Request No.	Category of information request	Applicant Response (02 July 2025)	
Flooding		Reason for request	
FR-01	Flood Risk	Adverse effects on downstream properties - There are noticeable increase of flood depth and extent at some downstream and upstream properties. The most significant effect will be increased flooding at the trafficable lanes and northbound off ramp at SH1. The post development peak depth at the upstream side of SH1 is predicted to reach more than 10m with an increase of 0.31m. This is due to the limited capacity of the 2.05m ID culvert. Please consider options to improve the culvert capacity. - The increased flood depth at the upstream property at 180 Upper Orewa Road is counter-intuitive, it is mostly likely a model data issue unless it is specifically designed to provide flood attenuation at this location. Please clarify. 	- The increased depth at the northbound lane is due to a localized inflow being applied at that location. This should not differ between pre- and post-development. The updated model will correct this anomaly. - Regarding the culvert, the design has been developed through an iterative modelling process to balance upstream storage and ensure

FR 03

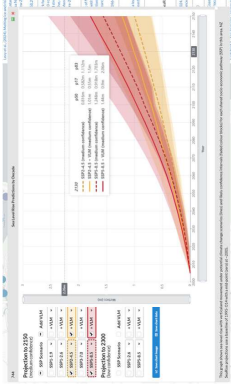
A normal depth water level boundary is adopted in the HEC-RAS model with a hydraulic gradient of 0.02 or 2% assumed for the receiving estuary channel. A constant tidal level boundary which takes into account of Sea Level Rise (SLR) and Vertical Land Movement (VLM) is considered more appropriate. The SLR scenario should be as per the Coastal Hazards and Climate Change Guideline (July 2024, MfE) for up to year 2130.

Tidal level can have an impact on flood levels.

The model has applied an initial tide level condition of 3.1mRL which comprises of a mean high water springs (2.1m) plus 1m in sea level rise. The MHWs level was obtained from Council RFHA Model Build with values ranging from (1.1mRL – 2.0mRL – NZVD2016)

The SLR with an allowance for VLM based on the 50th Percentile is as follows

- SSP2-4.5 – 1.01m
- SSP2-8.5 – 1.44m

Assuming the worst-case scenario, this brings the total tide level to 3.54mRL

We believe given the invert measured at the motorway is at RL 6.3, the tidal level is well below the invert level, the backwater effect outlet of the culvert at this area will be negligible.

The model is currently being updated with downstream condition applied as a stage hydrograph representing the tidal condition.
